Product Change Notice (PCN)

PCN Number: PCN-0451100R-01

Product(s) Affected: SJD1-3201-54

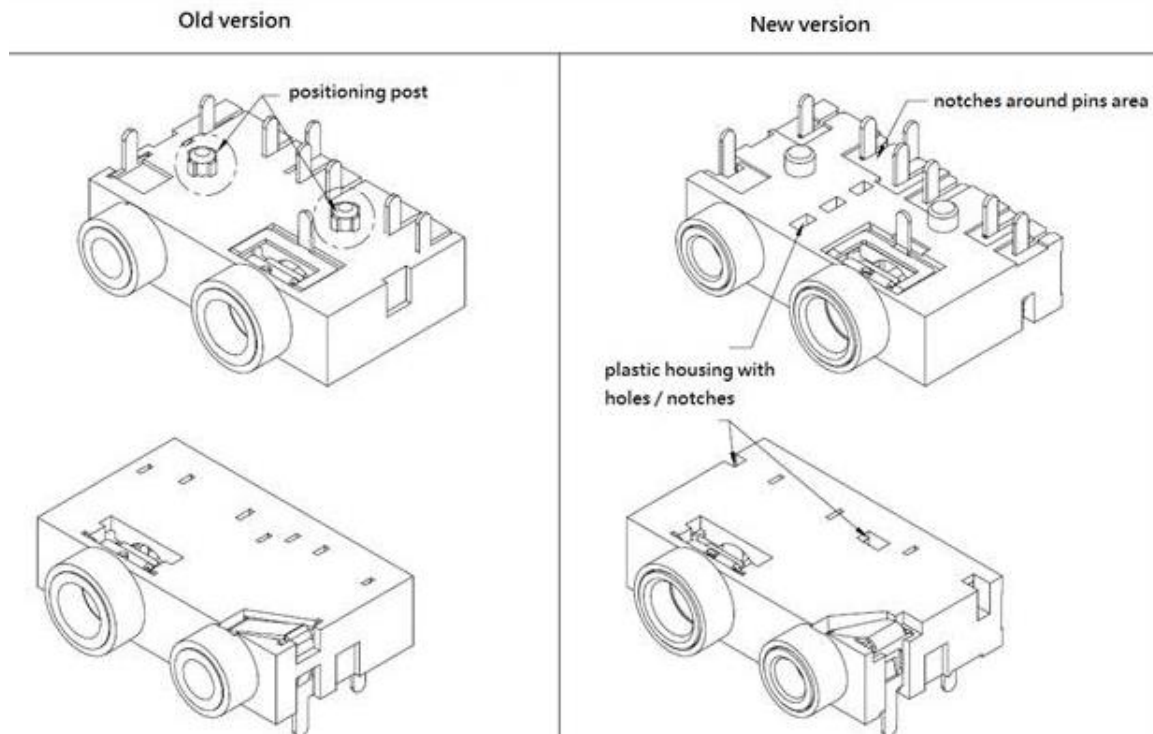
Description of Change: new tooling mold causes slight different appearance:

Additional Information: No change to other product dimensions or specs
